# UNITED STATES PATENT AND TRADEMARK OFFICE

APPLICATION NO.	FILING DATE	FIRST NAMED INVENTOR	ATTORNEY DOCKET NO.	CONFIRMATION NO.
10/541,336	02/06/2006	Chizuhiro Shiraishi	3796.P0049US	7727

<b>Office Action Summary</b>	<b>Application No.</b>		<b>Applicant(s)</b>	
	10/541,336		SHIRAISHI ET AL.	
	<b>Examiner</b>		<b>Art Unit</b>	
	Quang T. Van		3742

**Fig. 3**

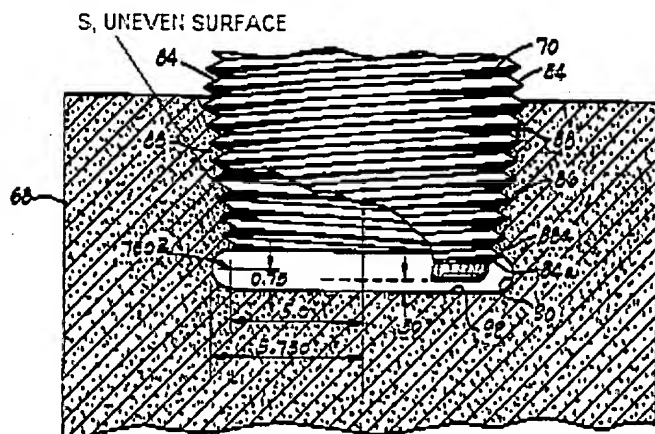
4. Claims 1-3 are rejected under 35 U.S.C. 103(a) as being unpatentable over Sakurai et al (US 5,795,539) in view of Markarian et al (US 4,161,619). Sakurai discloses a method for cooling graphite electrodes used for metal melting which is operated while cooling the graphite electrode (10) which protrudes upward from the furnace roof (1) by spraying a cooling liquid onto the surface of the graphite electrode (col. 7, lines 19-24). However, Sakurai does not disclose an uneven surface structure is formed on the surface of the electrode. Markarian et al (US 4,161,619) discloses an uneven surface structure (S, figure below) is form on the surface of the electrode (68). It would have been obvious to one having ordinary skill in the art at the time the invention was made to utilize in Sakurai an uneven surface structure is formed on the surface of the electrode as taught by Markarian in order to engage with a socket to joint two electrode sections together.
